UNITED STATES
NUCLEAR REGULATORY COMMISSION

SUBJECT: FINAL SIGNIFICANCE DETERMINATION FOR A WHITE FINDING AND
NOTICE OF VIOLATION (VOGTLE ELECTRIC GENERATING PLANT - NRC
INSPECTION REPORT NOS. 05000424/2006011 AND 05000425/2006011)

NOTICE OF VIOLATION

LIST OF ATTENDEES

FIGURE 2 - REACTOR COOLANT SYSTEM (RCS) INTEGRITY

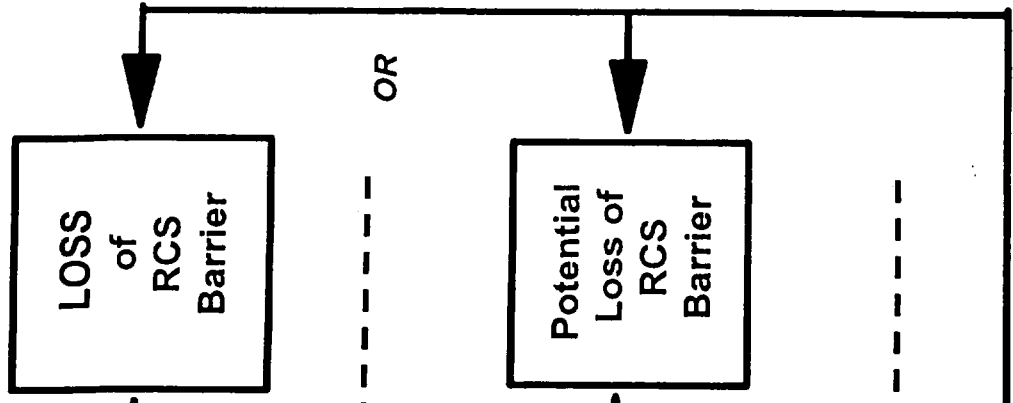
Emergency Classification and Implementing Instructions, 91001-C, is used to make the Emergency Action Level (EAL) determination. Figure 2 of the Emergency Classification and Implementing Instructions, identifies four conditions that can result in a determination of a potential loss of the RCS Barrier:
